Lyle Marshall & Partners Pty Ltd

Re: Sydney Harbour Bridge Cycleway – Northern Access Proposal. Response of Review of Environmental Factors Report.

This firm has been engaged by the Milsons Point Community Group to respond to the Review of Environmental Factors report currently on exhibition.

FIGURE 2 PROPOSED DESIGN DRAWINGS FROM ASPECT STUDIOS - COMMENTS

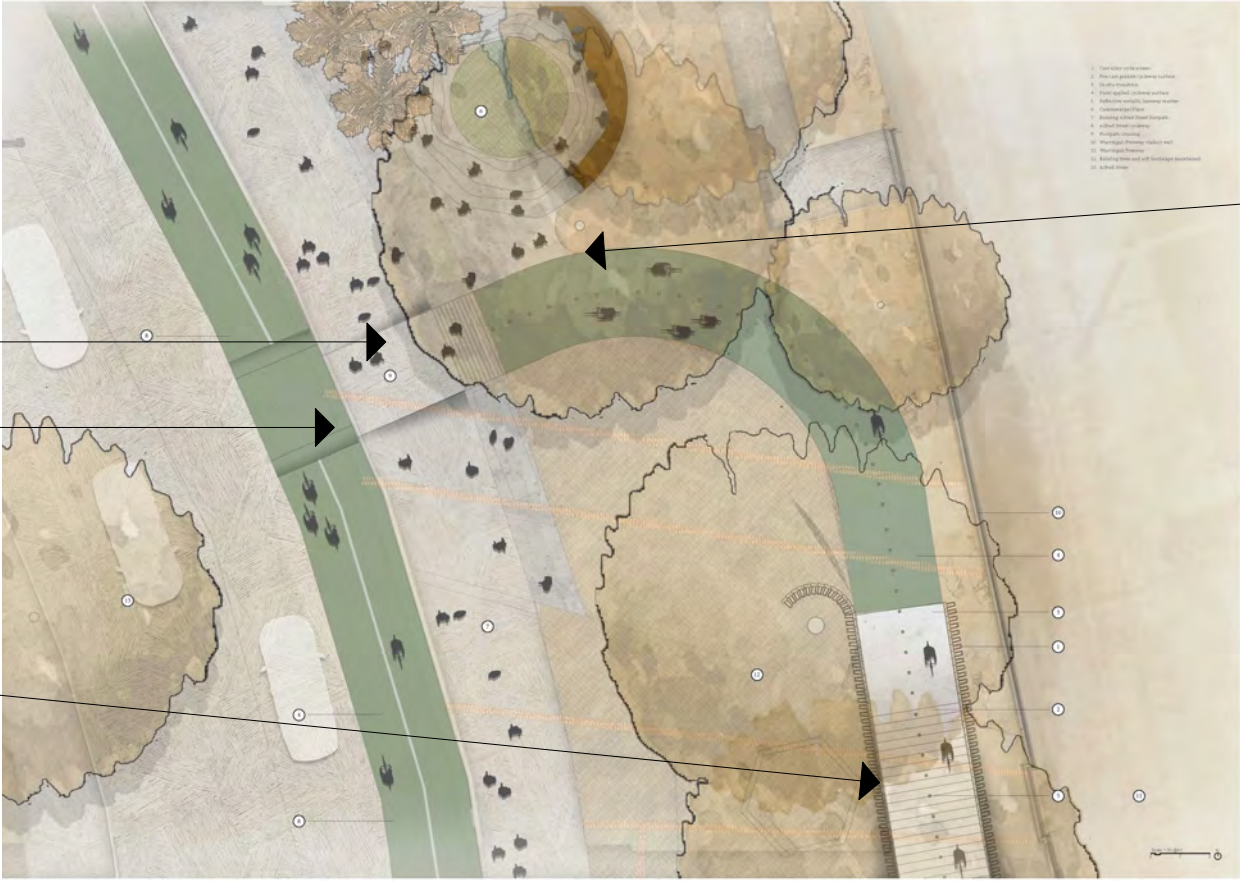
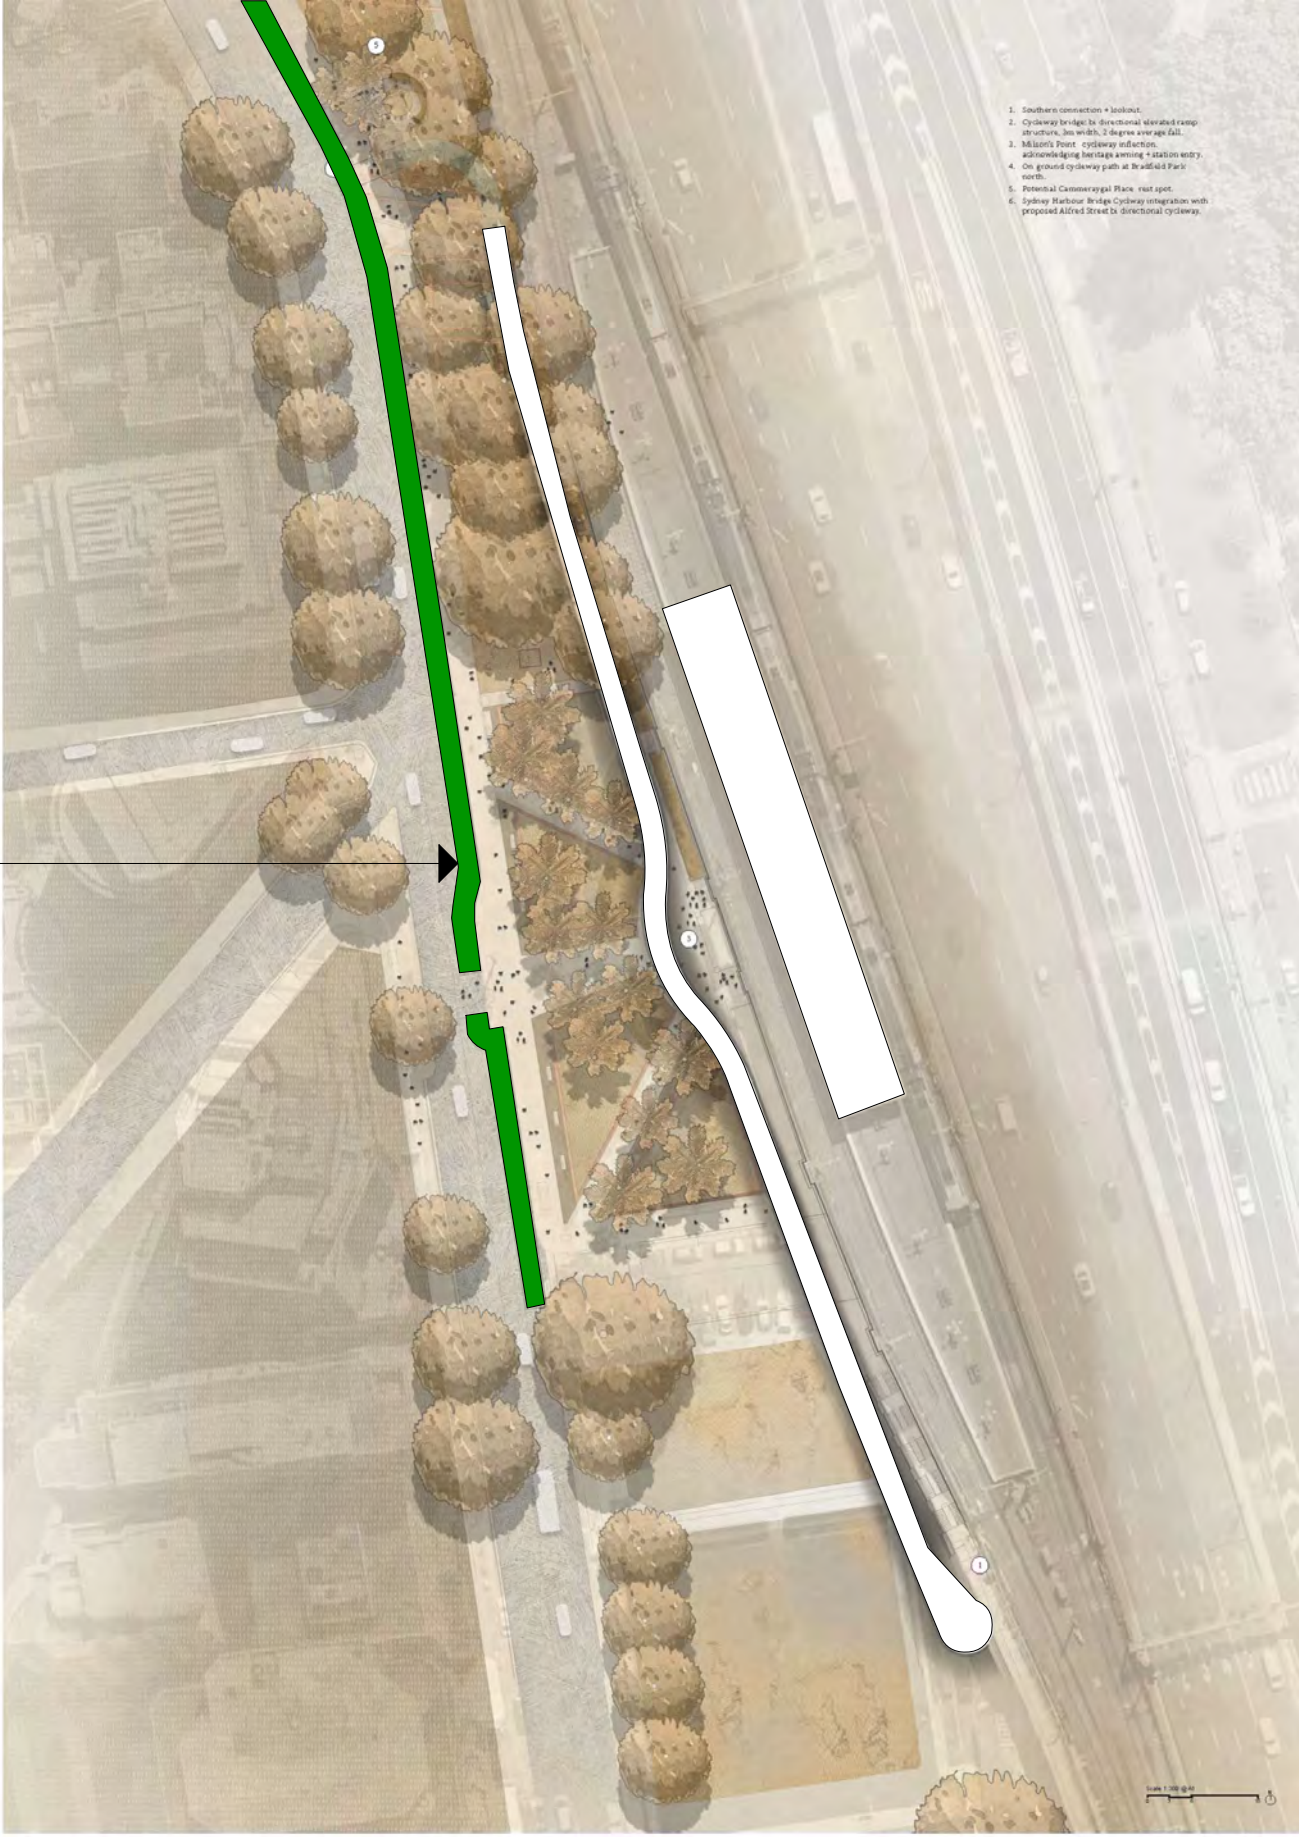
separation of heritage links in Bradfield North Park

drawing shows levels change to surrounding area separated cycleway on road pavement not shown in REF documentation

opportunities for loitering under cycleway

separated cycleway on road pavement not shown in REF documentation

relocation of crossing only 5.5m from holding line

planting shown on design plan could obscure sight lines to intersection

removal of 4 spaces and motorbike parking
driveway to 102-108 Alfred St South

footpath widening
removal of 2 spaces

opportunities for loitering under structure, unsafe for visual surveillance

planting shown over road boundary

removal of 6 spaces

relocation of bus zone within traffic lane

removal of 3 spaces

column positions obstructing pedestrian pathway

FIGURE 4 PROPOSED LANDSCAPE- COMMENTS ON CYCLE STRUCTURE AND LANDSCAPE DESIGN

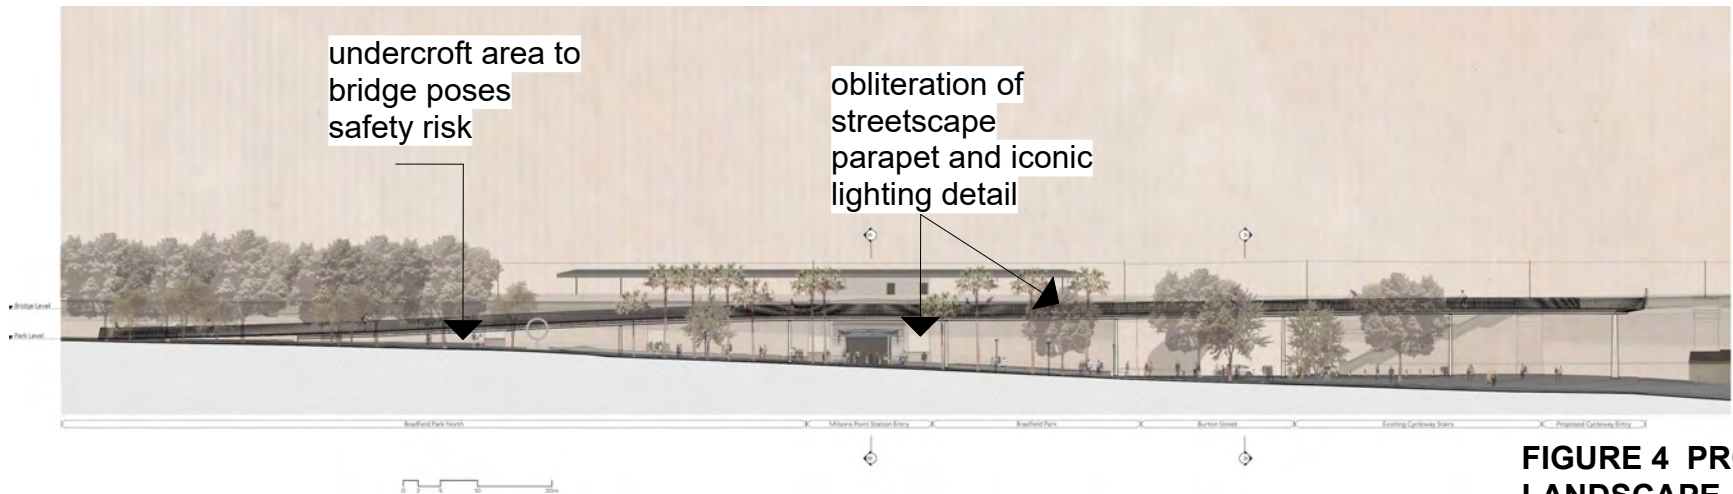
We refer to the elevational detail replicated in **Figure 4** of this report and **Photographs P1** and **P2**. The proposed cycleway structure will block important streetscape elements such as the lighting details at the Milsons Point entrance and parapet detailing for some metres along the length of the structure.

There are potential problems which can occur with loitering under the lower section of the bridge and this could become a potential safety risk to pedestrians. There are also opportunities for persons to hide behind the large columns which have a diameter at the base of 900mm x 700mm ellipses as referenced on page 59 of the REF document.

The base is wide enough for persons to hide behind and will affect safety of pedestrians entering and exiting the Railway Station entrance particularly at night. A social impact statement has not been provided with the REF.

undercroft area to bridge poses safety risk

obliteration of streetscape parapet and iconic lighting detail

FIGURE 5 ALTERNATIVE DEISGN
OVERLAY

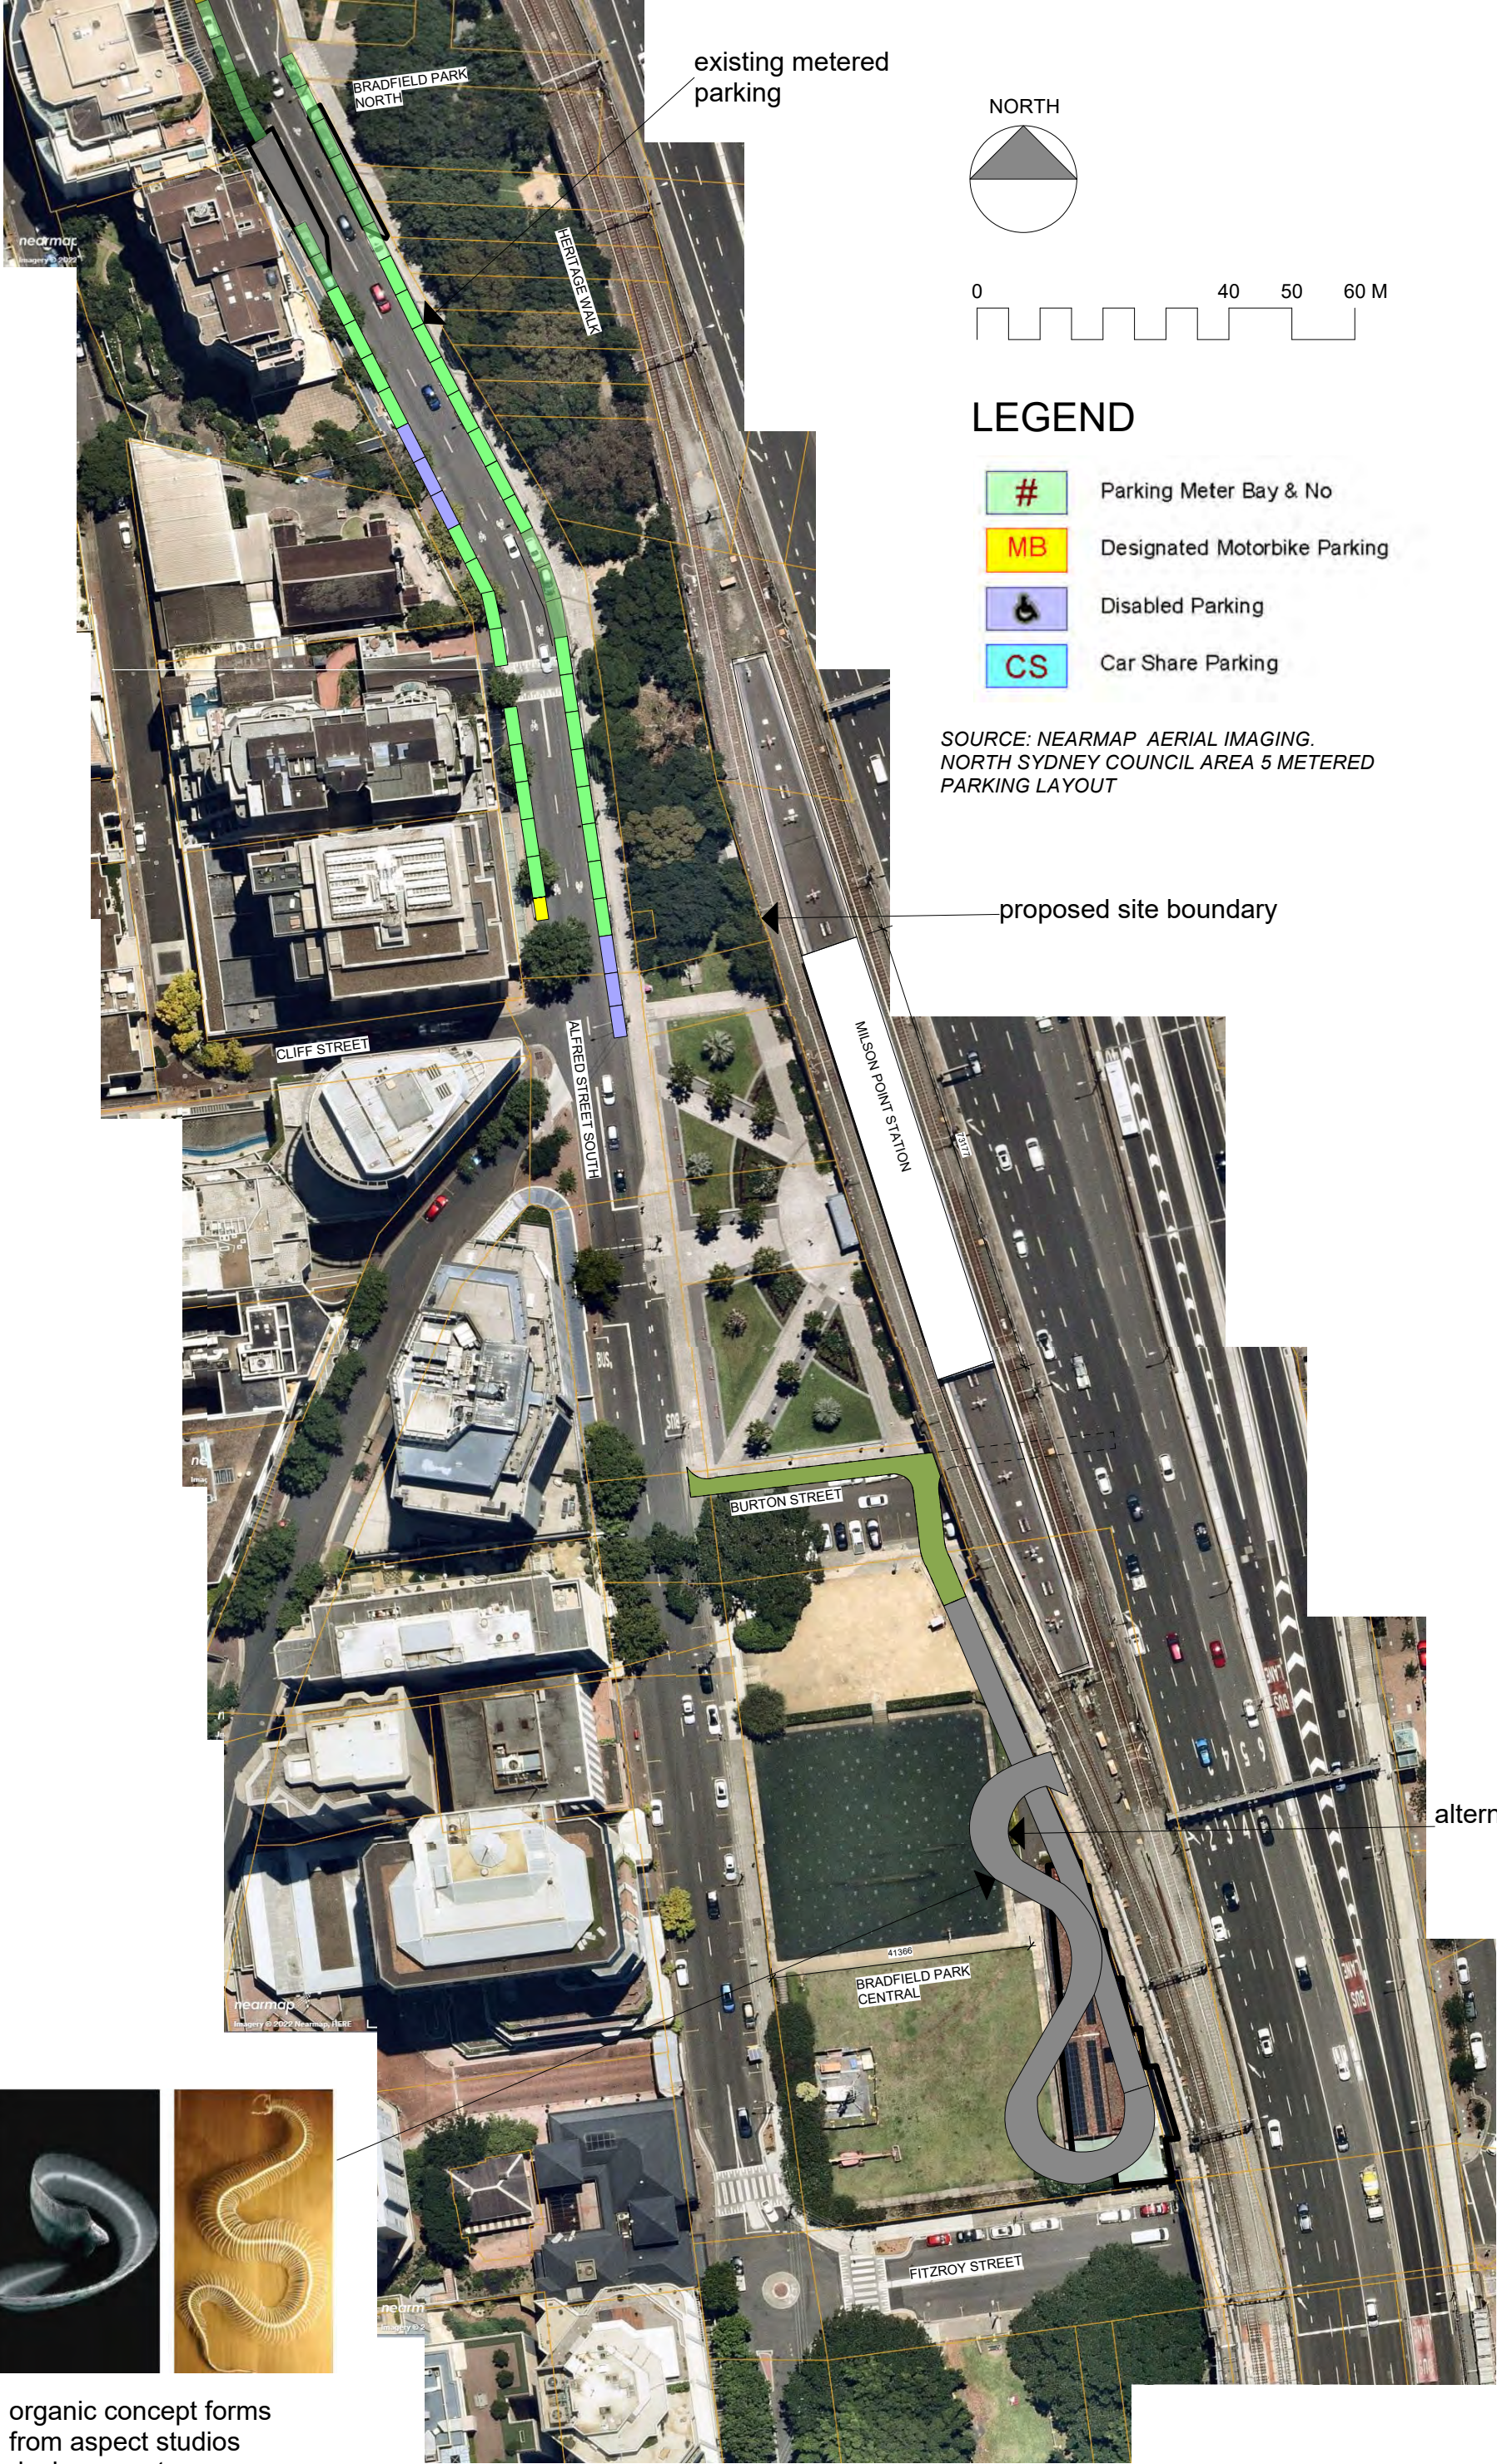
The alternative design seeks to minimise any disturbance to the heritage walk, forecourt area and elevation character of the Milsons Point Railway Station entrance. It does not require the removal of any trees or forecourt landscaping.
